# SAN FRANCISCO PLANNING DEPARTMENT

## Discretionary Review Abbreviated Analysis HEARING DATE: MARCH 14, 2019

*Date:* February 28, 2019  
*Case No.:* **2016-006123DRP-02**  
*Project Addresses:* **279 Bella Vista Way**  
*Permit Applications:* 2016.0421.5348  
*Zoning:* RH-1[Residential House, Single-Family]  
40-X Height and Bulk District  
*Area Plan:* N/A  
*Block/Lot:* 2998/021  
*Project Sponsor:* Matt Hollis  
Matt Hollis Architects  
2325 Third St. suite 224  
San Francisco, CA 94107  
*Staff Contact:* David Winslow – (415) 575-9159  
[David.Winslow@sfgov.org](mailto:David.Winslow@sfgov.org)  
*Recommendation:* **Take DR and Approve with modifications**

The project consists of construction of a 228 s.f. horizontal rear addition at the ground level, and a 591 s.f. horizontal rear addition at the second floor of an existing 2-story, single-family dwelling.

**A2.04**

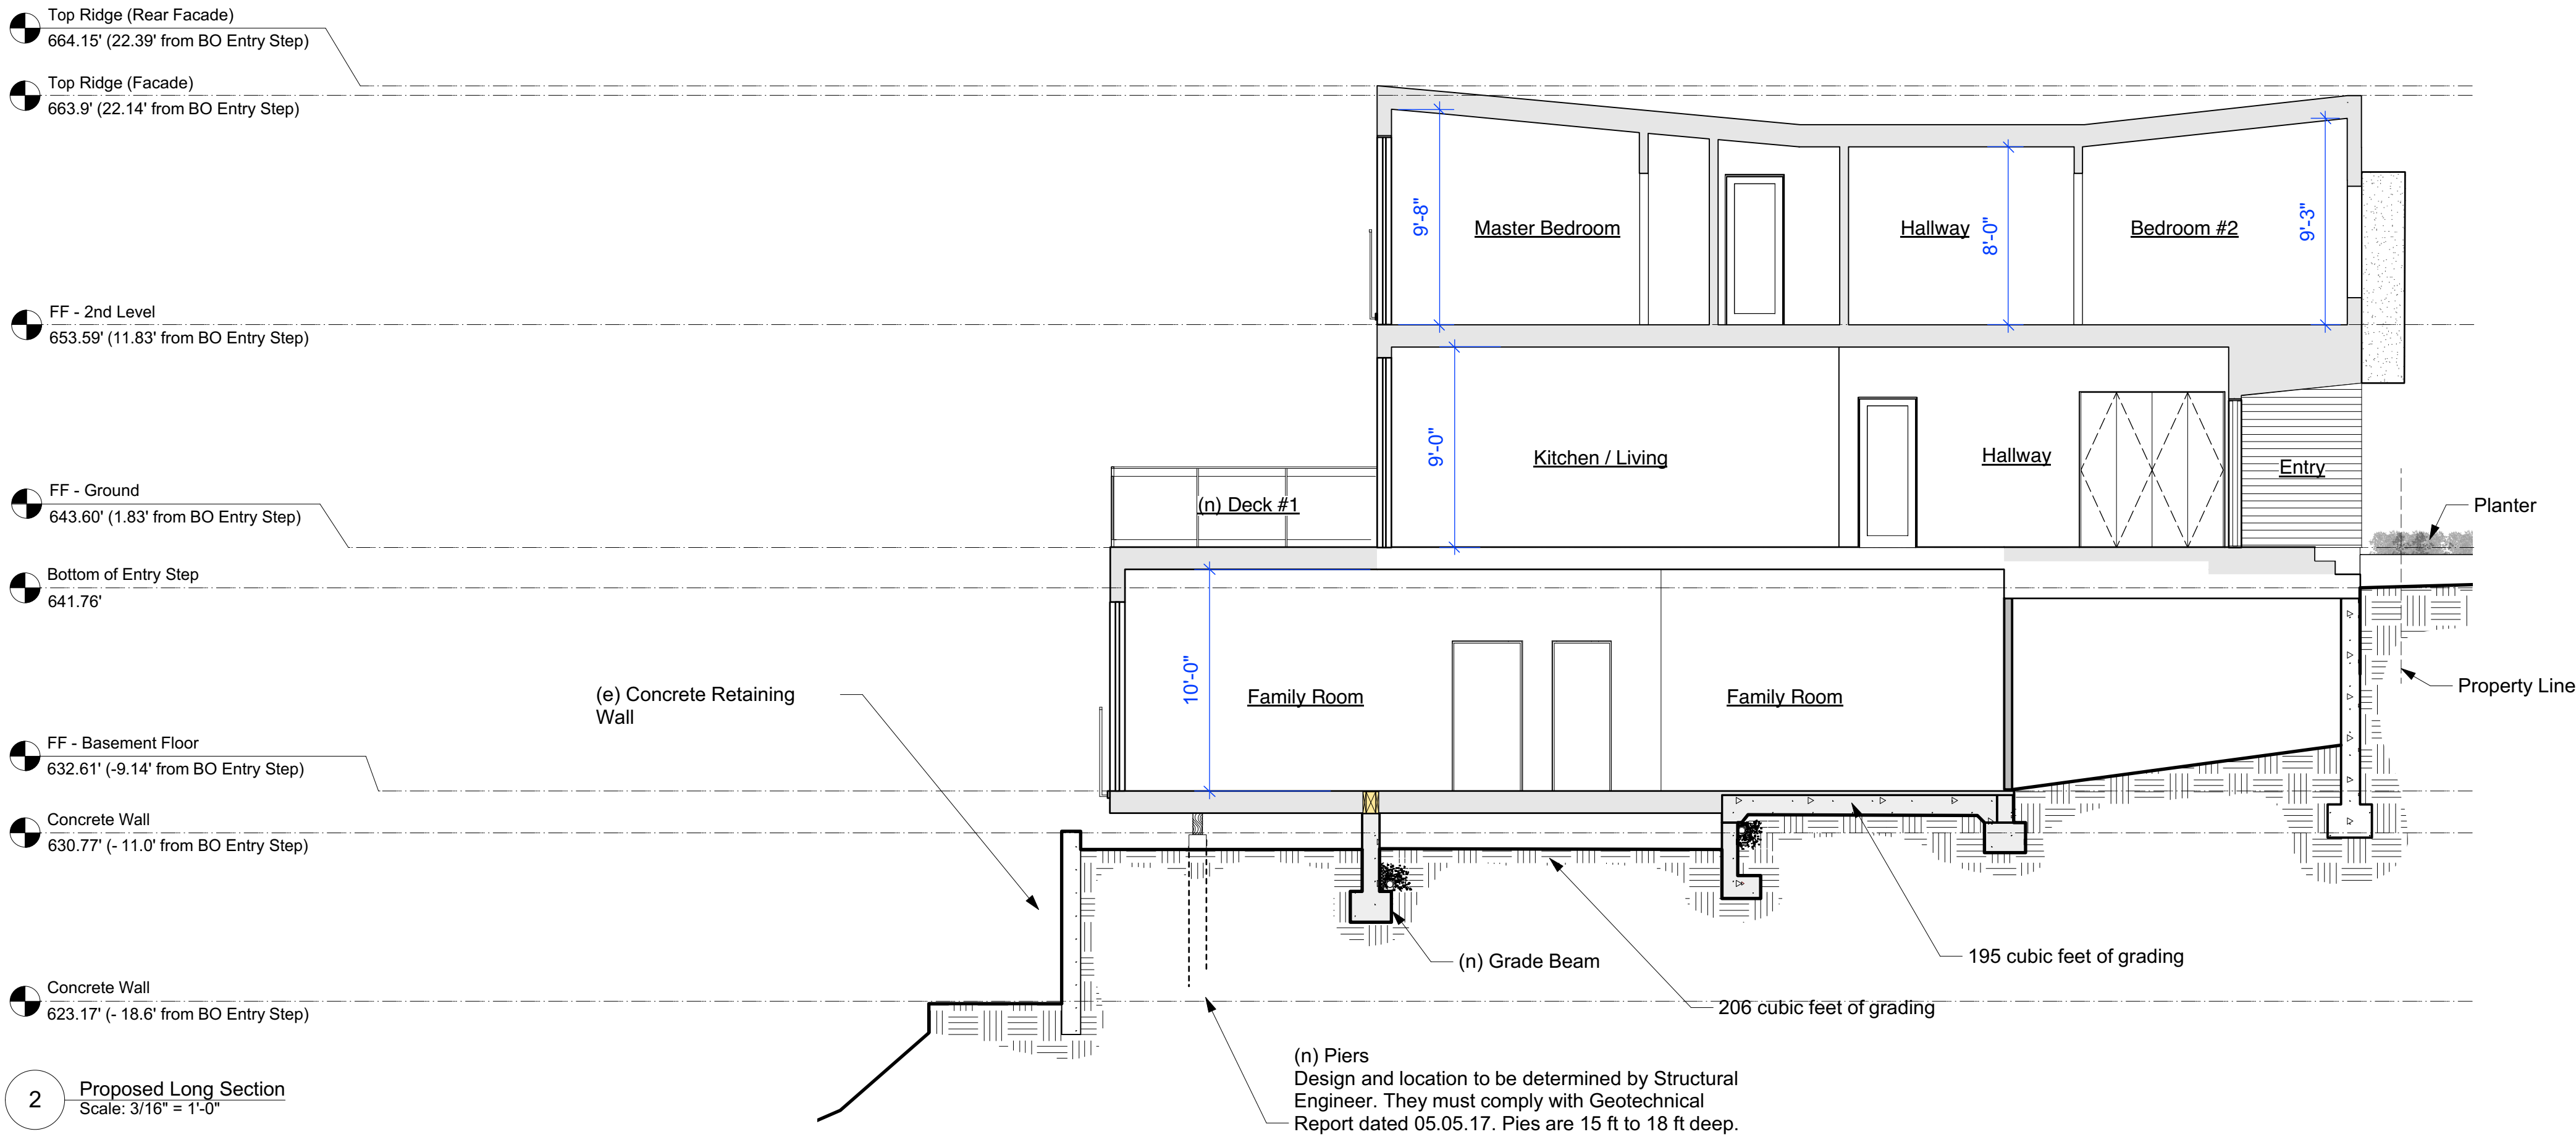
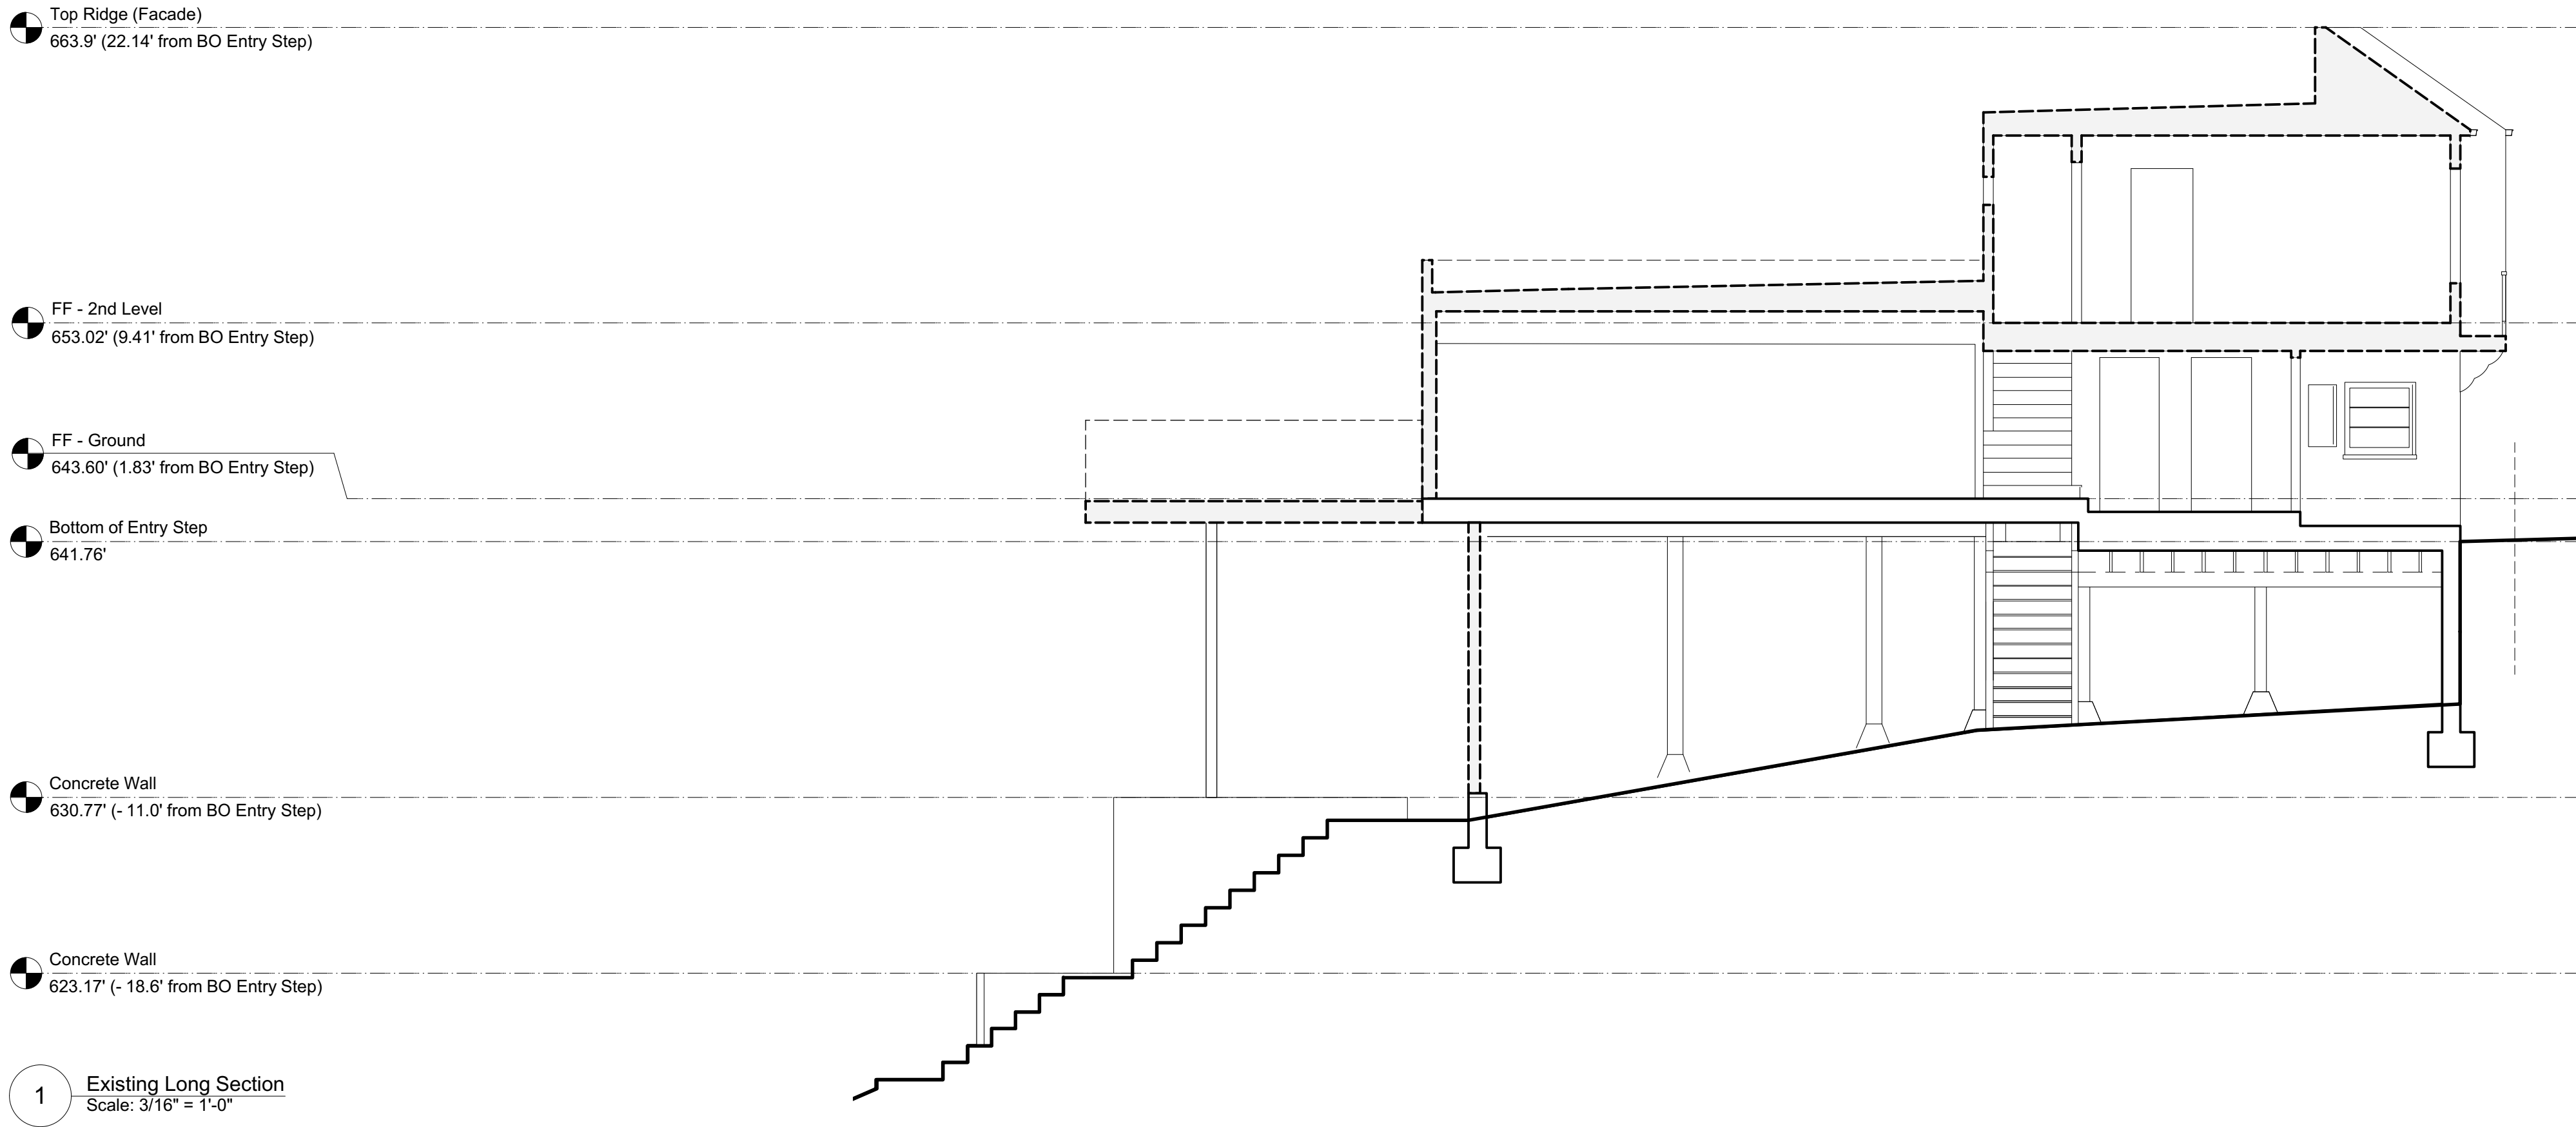
2. The elevation drawings on sheets A2.03 and A2.04 are mislabeled in terms of the directions they face and the proposed deck on the Proposed First Floor Plan on sheet A1.02, Deck #1, isn't labeled. Also, I don't see the profile of our houses on the elevation drawings. Finally, the elevations don't note the proposed finish materials on the sides of the addition. Therefore, I ask that the drawings be revised to provide this legibility.

4. Related to #7 below under Facade Remodel, the proposed side elevations on sheets A2.03 and A2.04 show that tall walls would be visible from my top floor. It's unclear from these drawings what ceiling height is proposed at the top floor or what the addition height would be above my roof. In order to lessen the scale and negative impact of the proposed top floor addition, I ask that the level of the second floor remain at the existing location, that the ceiling height at the top floor be no higher than 9' in order to make the addition more in scale with the adjacent buildings, and that the height of the addition above my roof be noted on the relevant elevation. Avoiding an oversized scale is addressed on page 39 of the MPRDG.

2. The elevation drawings on sheets A2.03 and A2.04 are mislabeled in terms of the directions they face and the proposed deck on the Proposed First Floor Plan on sheet A1.02, Deck #1, isn't labeled. Also, I don't see the profile of my house on the elevation drawings. Finally, the elevations don't note the proposed finish materials on the sides of the addition. Therefore, I ask that the drawings be revised to provide this legibility.

4. Related to #7 below under Facade Remodel, the proposed side elevations on sheets A2.03 and A2.04 show that tall walls would be visible from my top floor. It's unclear from these drawings what ceiling height is proposed at the top floor or what the addition height would be above my roof. In order to lessen the scale and negative impact of the proposed top floor addition, I ask that the level of the second floor remain at the existing location, that the ceiling height at the top floor be no higher than 9' in order to make the addition more in scale with the adjacent buildings, and that the height of the addition above my roof be noted on the relevant elevation. Avoiding an oversized scale is addressed on page 39 of the MPRDG.
